Banbury 200 Unit,
 Southam Road, Banbury
 Proposed Site Plan

Drawing Status:	Planning
Drawn / Checked:	DG / AS
Date:	03.01.19
Scale:	1:500 A1
Drawing no:	Revision:
16083 P0002	A

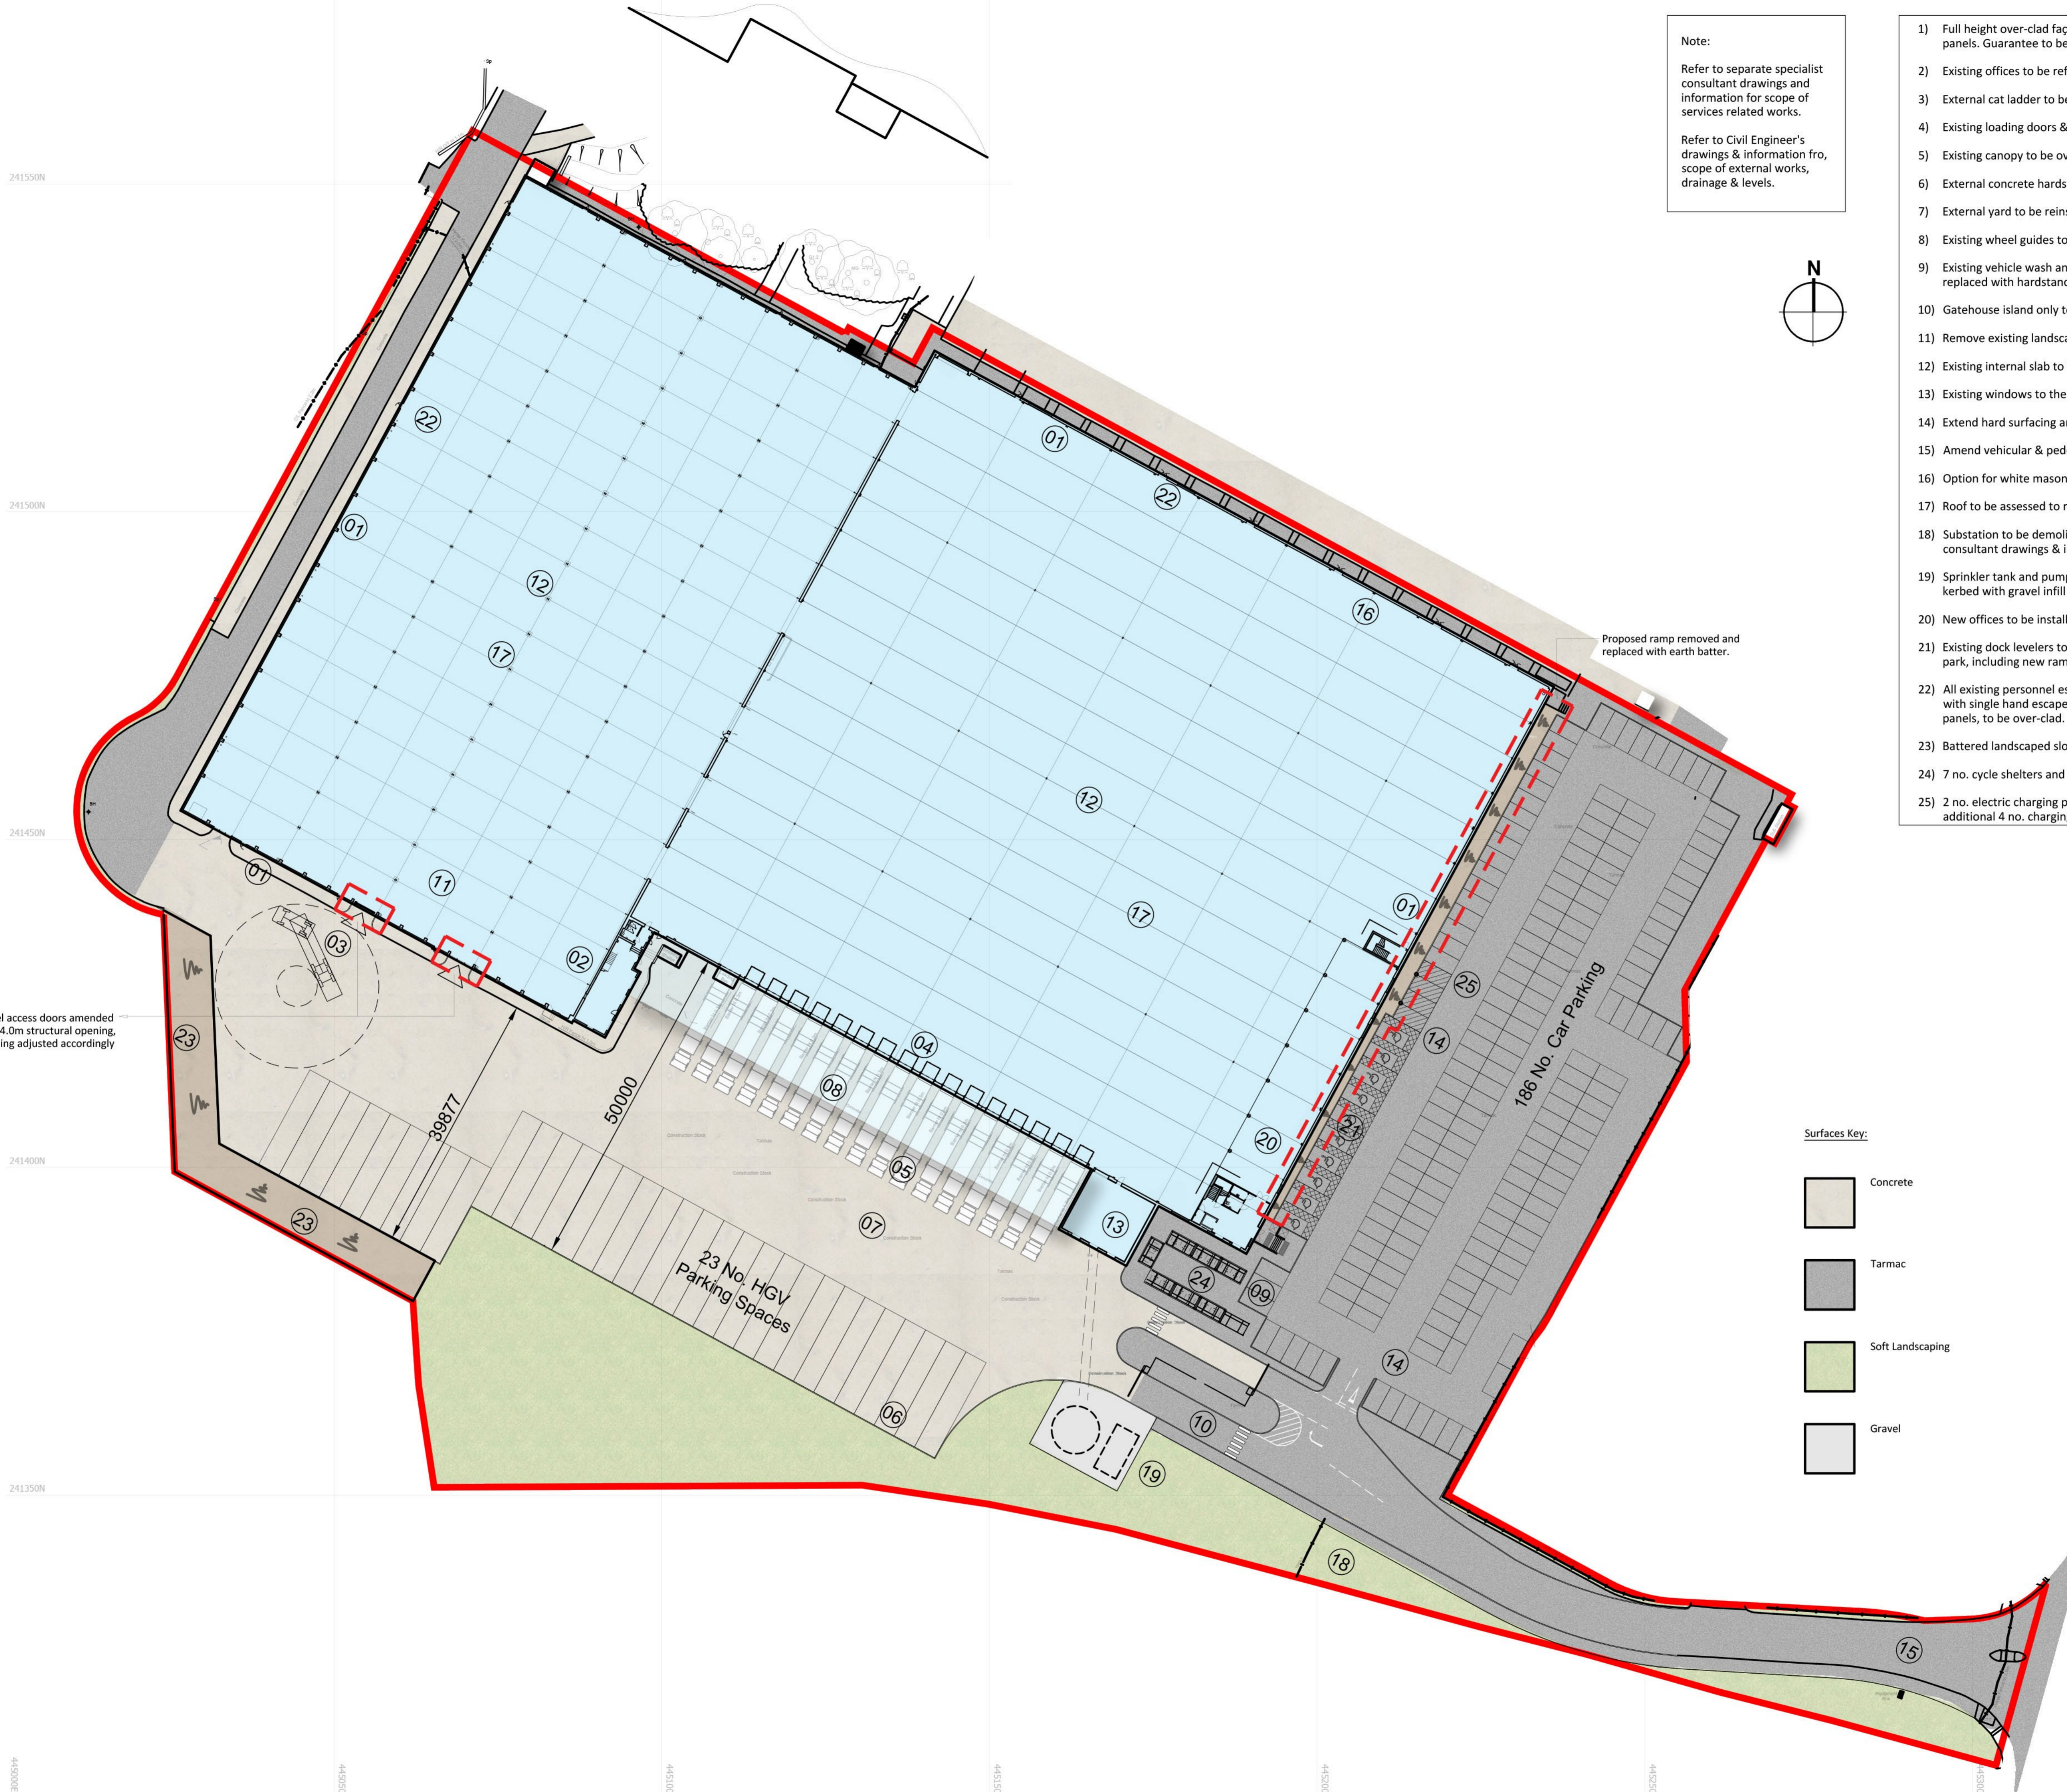
Two level access doors amended to suit a 4.0m structural opening, and kerbing adjusted accordingly to suit.

Proposed ramp removed and replaced with earth batter.
